# Technical Service Information

## THM 4L60-E PUSH-IN COOLER LINE FITTINGS

Figure 1

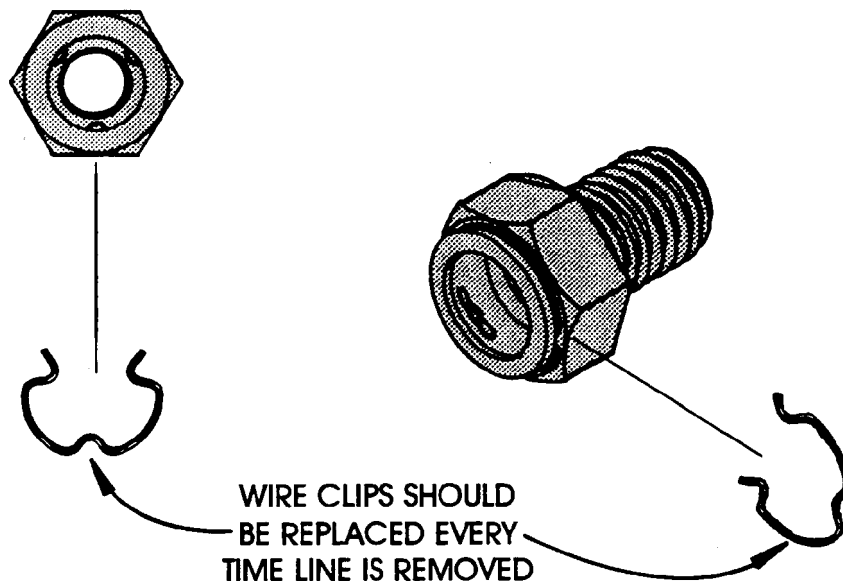
**CHANGE:** Beginning at the start of production for 1996 models, all “C” and “K” Trucks and “G” Vans were built with a new design “Push-In” cooler line fittings for the transmission (See Figure 1).

**REASON:** Ease of installation at the Truck Assembly Plants.

VEHICLE COOLER LINES - Modified oil cooler lines to accommodate the new design “Push-In” transmission cooler line fittings.

NOTE: General Motors recommends that the retaining “Clip” in the new design cooler line fittings be replaced every time that the cooler line is removed.
